Addendum # 1

**Bid Opportunity: RFP-549-2024 - General
Contractor Renovation MPAC Pickering, 10th
Floor**

End of Addendum Number: AD-01

drawing title
DEMOLITION PLAN

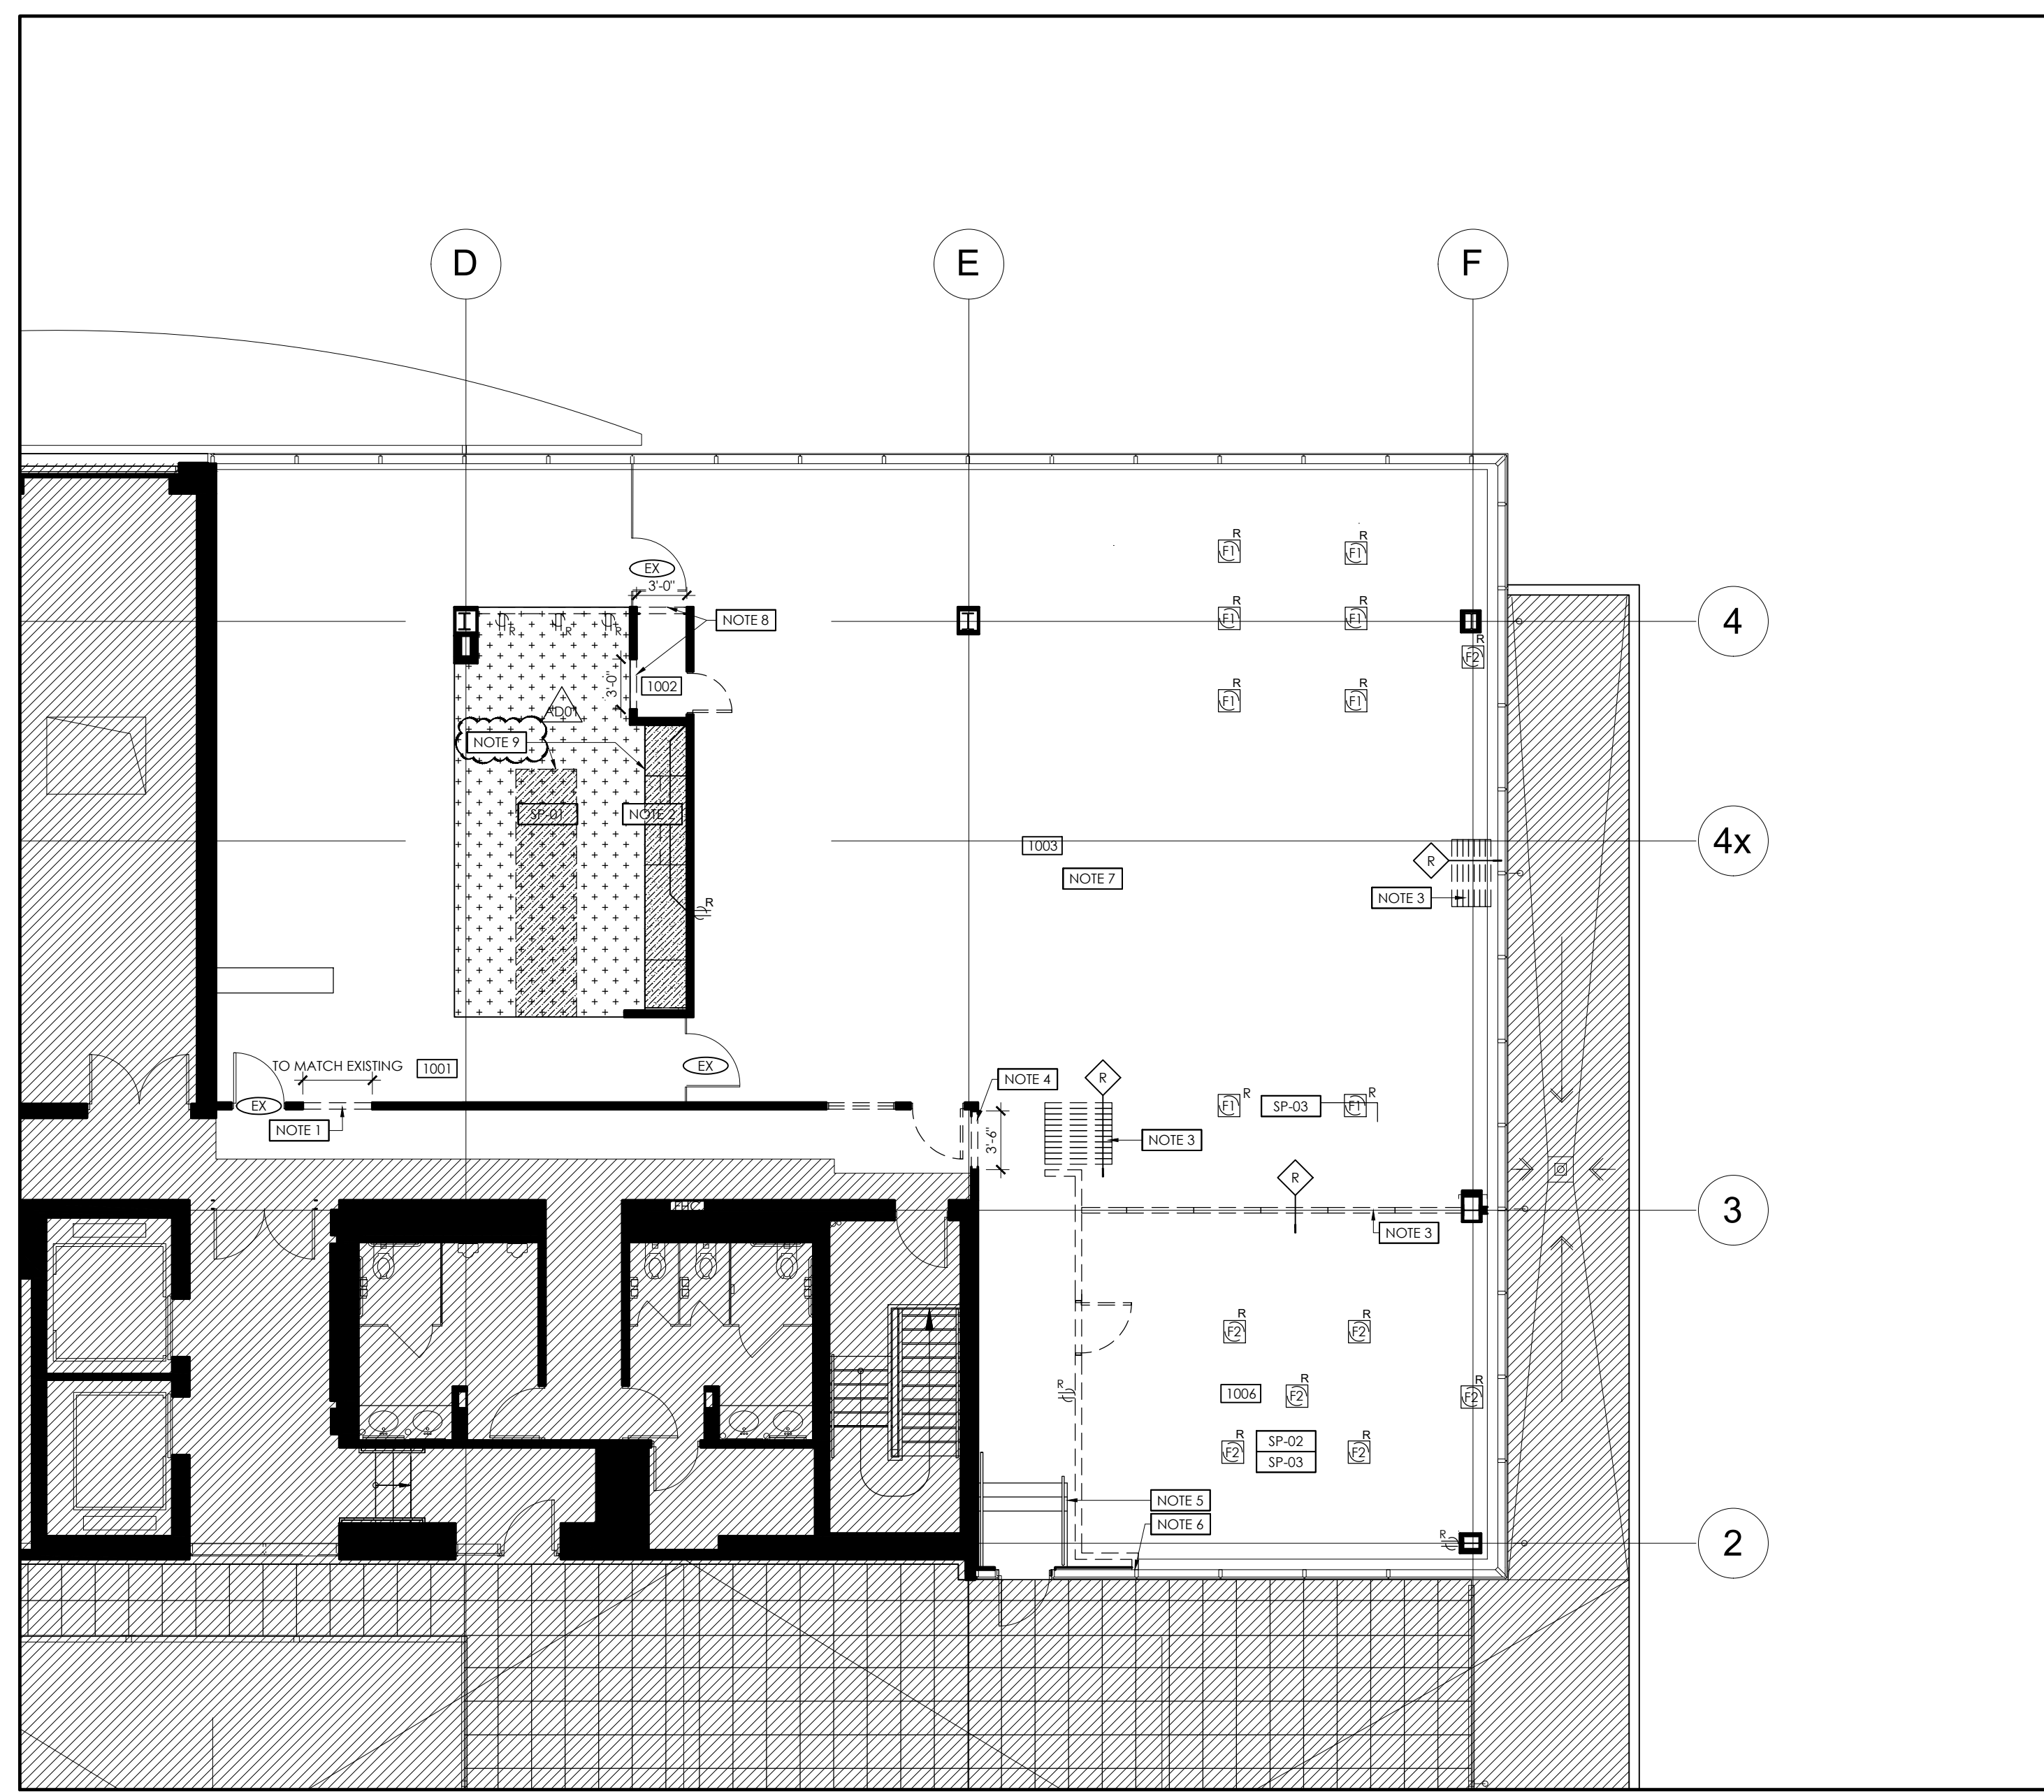
8.0	Referencing I-1008: There is a new millwork in Cafe 1001, do we remove the existing kitchen cabinet and island? Demo plan does not have this scope. Please confirm.

15.0	On the Demolition drawing I-1000 Note 7 It is written that we need to replace the Carpet. But in the Flooring drawing Carpet C-1 shall be separate price not sure if we are doing flooring work in base bid or separate item

Answer: All existing millwork at Café is to be removed.
9.0	Referencing I-1007: Please provide details and spec for Door type C.
	Answer: No door type C, Schedule updated to note door type B to match details.

Answer: All flooring should be a separate price item.

1 PARTITION PLAN
1/8" = 1'-0"

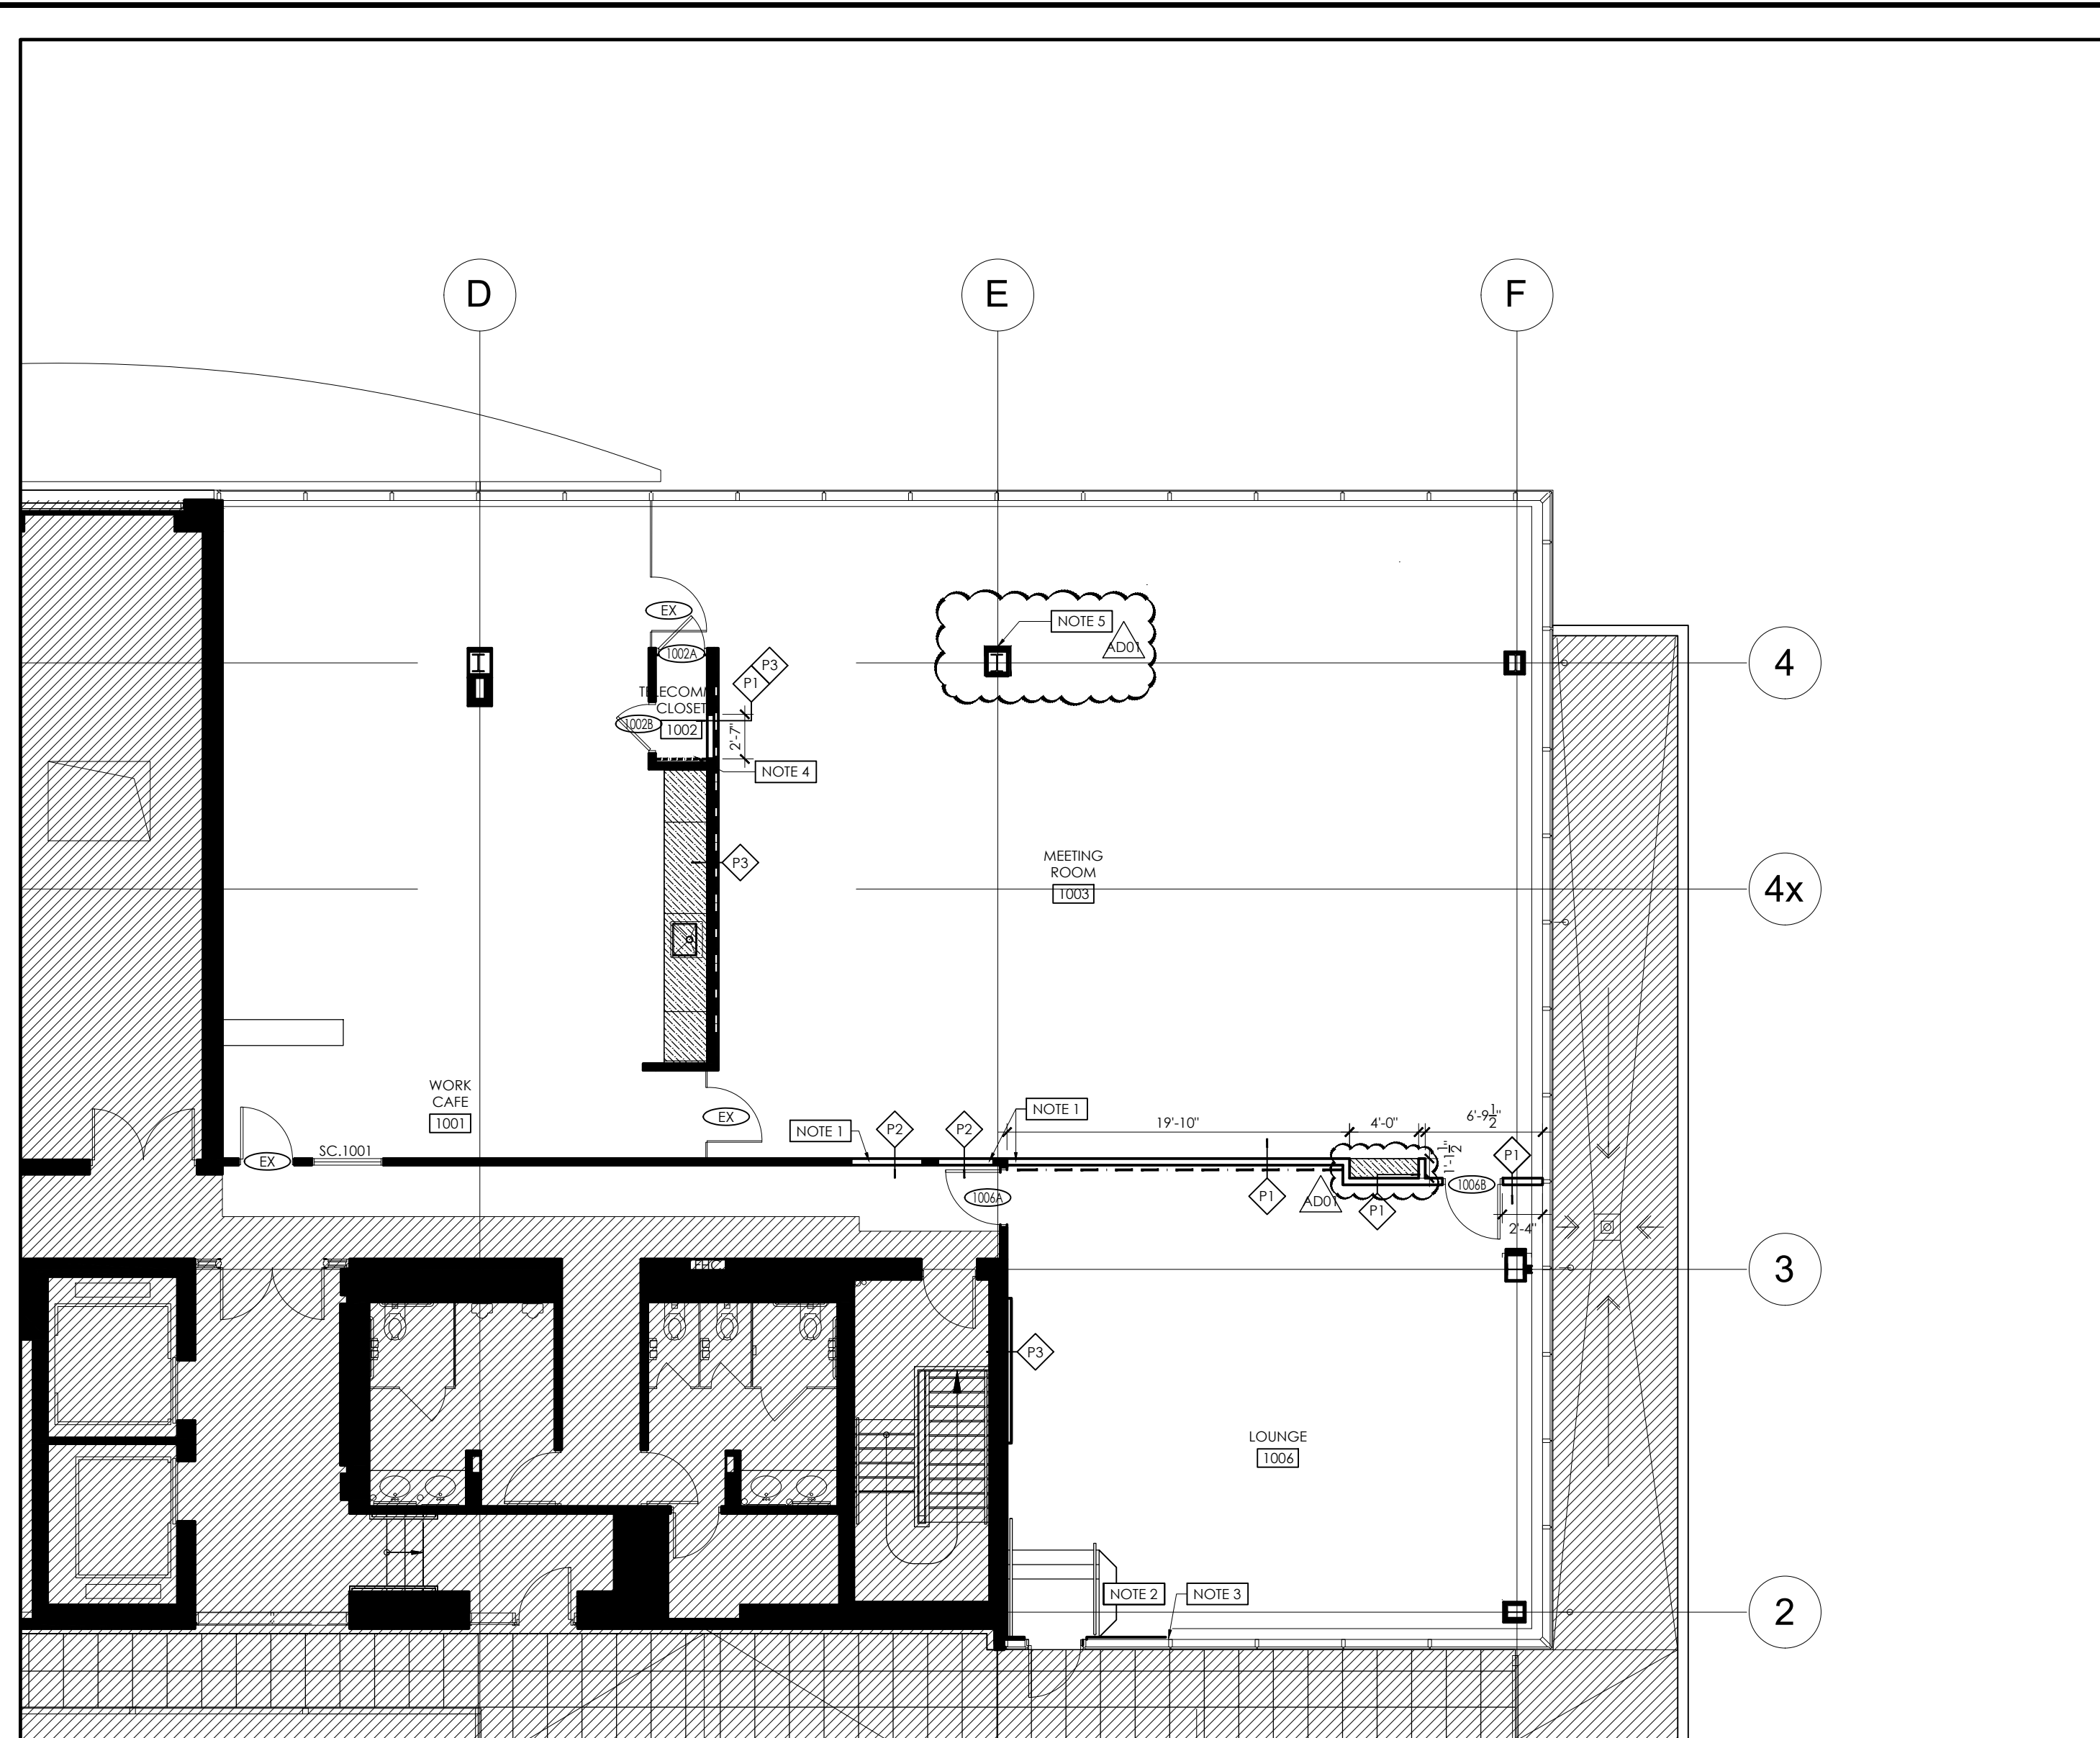
2.0	Elevation 2 on drawing I-1008.1, there are 4 elevations with this heading. For the elevations with the shelves and 2 doors (below Plan: Area) , Are there any details for these shelves and doors ? Elevation 3/I-1008.1 lower left corner, what are the 2F 6 Inch x 5 F-4 Inch panels? Which columns are to receive what look like coat hooks?

13.0	Referencing I-1008.1 Detail 2: Please confirm how many of the columns we have to clad?
	Answer: No cladding required, mark up of location of coat hooks provided with this Addendum, Refer I-1001, Note 5.

Answer: Drawing numbering has been redlined and attached with this addendum response. 1-1/2” thick shelves to be adjustable on recessed pilasters, PL1 interior. Doors PL-1 finish. Hardware PULL-2 Column with Coat hooks noted on partition plan issued with this Addendum. Refer I-1001
